A47 North Tuddenham to Easton

Volume 9 **9.31 Applicant's Responses to Deadline 7** **Comments**

**9.31 APPLICANT'S RESPONSE TO THIRD PARTY COMMENTS
AT DEADLINE 7**

Rule Number:	8(1)(c)
Planning Inspectorate Scheme Reference	TR010038
Application Document Reference	TR010038/EXAM/9.31
BIM Document Reference	HE551489-GTY-LSI-000-RP-TX-40024
Author:	A47 North Tuddenham to Easton Project Team, Highways England

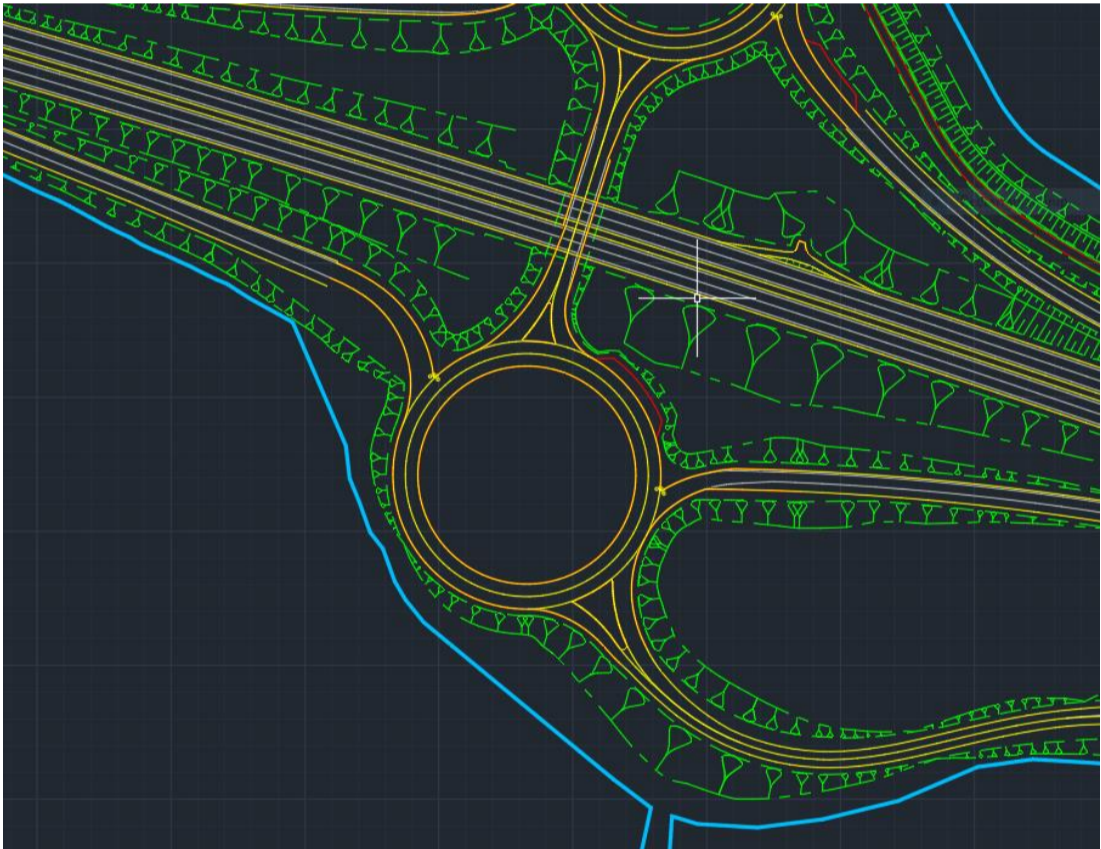
Comment	Applicant Response
<p>(REP7-023) / 11.</p> <p>Further, it is clear from the documents extracted in Appendix C that there are three critical parts of a junction for its safety and resilience, namely (1) entry width (2) approach width and (3) flare length. These are the three most important factors when determining a junction's form using the ARCADY software, while the remaining geometries (including ICD) have lesser effects (see App C, TRL RR142, para 4). The Applicant here is seeking to fix the ICD without having yet designed the three most important factors for all entries and exits to the junction (see the junction drawings which do not include these for the link road, the B1535 (Wood Lane), or the de-trunked A47), which it has confirmed to ACM will be done after the DCO is completed. In ACM's submission this places the cart before the horse and ACM invites the Examining Authority to require the Applicant to complete an indicative design which enables the roundabouts' size to be more robustly determined. It is also recommended in the manuals that the ICD size should take account of the landscape around it.</p>	<p>The Applicant has previously confirmed to Mr Meynell and his advisors at a meeting held on 11 August 2021 that all roundabouts had been proportionally designed in 3D with simple connections, however they were designed in 2D to ensure that entry width, approach width, flaring and deflection were provided / achieved in accordance with the UK DMRB.</p> <p>This information is a prerequisite for the ARCADY assessment for the Operational Modelling Assessment which is presented in Section 4.10 of the Case for the Scheme (APP-140).</p> <p>The Applicant used this 2D information to inform the "Highway Work Limit of Deviation" as shown on the Works Plans, Rev.2, Sheet 9 of 23 (AS-028). The below snapshot provides an overview of the preliminary design of the southern roundabout earthworks only with full 3D geometry design. The blue line shown is the "Highway Work Limit of Deviation".</p> <p>The design would be further developed during the detailed design stage and approved by the Secretary of State through dDCO Requirement 3 following consultation with the relevant planning authority.</p> <p>Snapshot of Southern Wood Lane Roundabout:</p>
